## SERVICE BULLETIN NO. 178

### Catch VCI

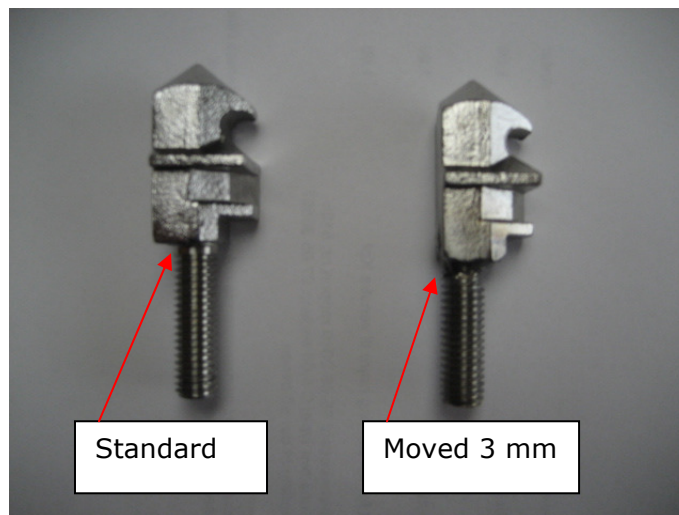
It turns out that when you replace the handle on Visual Cooking I ovens with the new handle for Visual Cooking II (30420013), it is not possible to move the catch far enough to the right.

To solve the problem, you can order a catch (20400267) whose thread has been moved 3 mm.
